Extended Span Kit

ISSUE DATE:	October 20, 2023	PART NUMBER:	54302 54303
SUBJECT:	Modular platform expanded span kit	PRODUCT LINE:	ErectaStep
TOPIC:	EXPANDED SPAN KIT FOR ERECTASTEP UNIVERSAL PLATFORMS

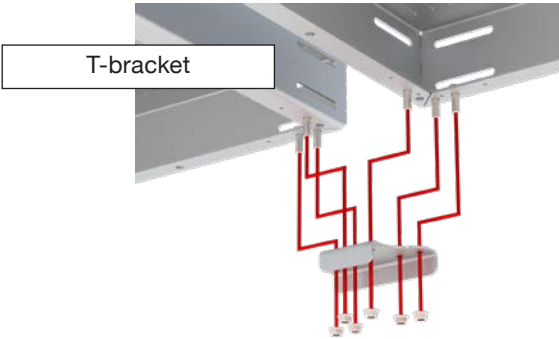
In October 2023, the ErectaStep engineers created the extended span kit for use with our modular 36” universal platform component. The brackets contained in this kit allow support for up to 5 platforms, when secured to two ErectaStep towers with tower to platform support brackets on either side.

The ErectaStep underside bent T-Brackets contained in this kit are designed to be used when configurations require unsupported spans longer than 3 platform but no more than 5 platforms.

Without ESK / Standard

Using ESK
